VECTOR 1950 ST & MT – NEW ELECTRONIC CONTACTORS

VECTOR 1350 NEW ELECTRONIC CONTACTORS

Polarity on C30 Contactor

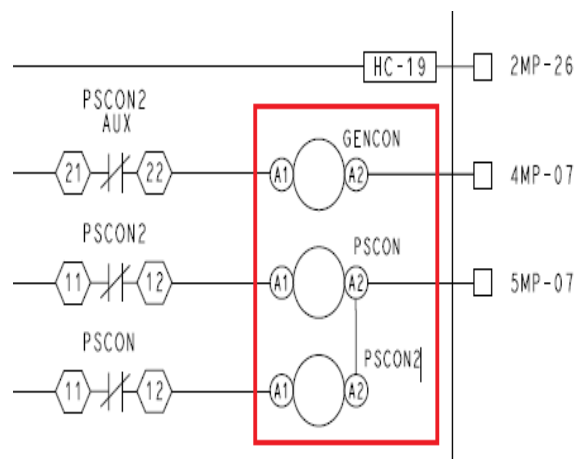
The new electronic contactors are a direct replacement for the old style but are polarized, and do not need the black auxiliary connection wires which can be discarded with the old contactor. It was possible to wire the positive and negative connections either way on the old magnetic contactor, but this is not possible on the new electronic type. Be careful to connect positive and ground connections as marked on the new contactor the correct way around.

Polarity on C30 Contactor

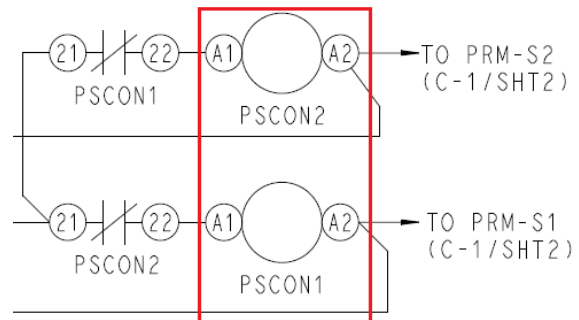
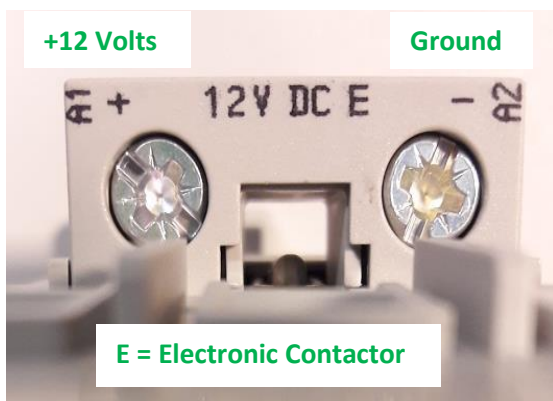
The new electronic contactors are a direct replacement for the old style but are polarized, and do not need the black auxiliary connection wires which can be discarded. It was possible to wire the positive and negative connections either way on the old magnetic contactor, but this is not possible on the new electronic type. Be careful to connect positive and ground connections as marked on the new contactor the correct way around.

Vector 1350

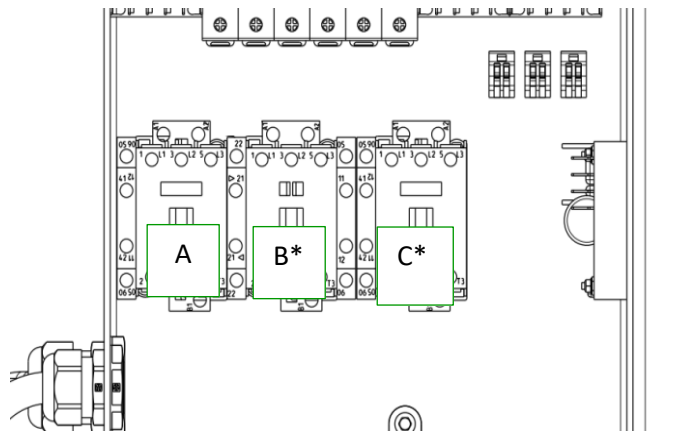
Replacement Parts: Previous Magnetic Contactors can be replaced by Electronic Contactors as P/N below:

* The PSCON2 contactor is only used on Vector 1350 AR3P (phase reversal) units.
This contactor is not used on Vector 1350 DPH (phase detector units)

* The SBMCON standby motor contactor used to have a left auxiliary as it was necessary on magnetic contactors for a connection between auxiliary and A1 terminal, and from auxiliary to B1 contactor terminal. With electronic contactors these connections are inside the contactor so this contactor SBMCON has been replaced with a contactor that does not have auxiliary.

Contactor	Old Contactor P/N	New Electronic Contactor P/N
A (PSCON1)	P/N 10-00433-06 Contactor with Auxiliary on left	P/N 10-00503-32 Contactor with Auxiliary on left
B* (PSCON2)	P/N 10-00433-00 Contactor with Auxiliary on right	P/N 10-00503-31 Contactor with Auxiliary on right
C* (SBMCON)	P/N 10-00433-06 Contactor with Auxiliary on left	P/N 10-00503-30 Contactor without auxiliary
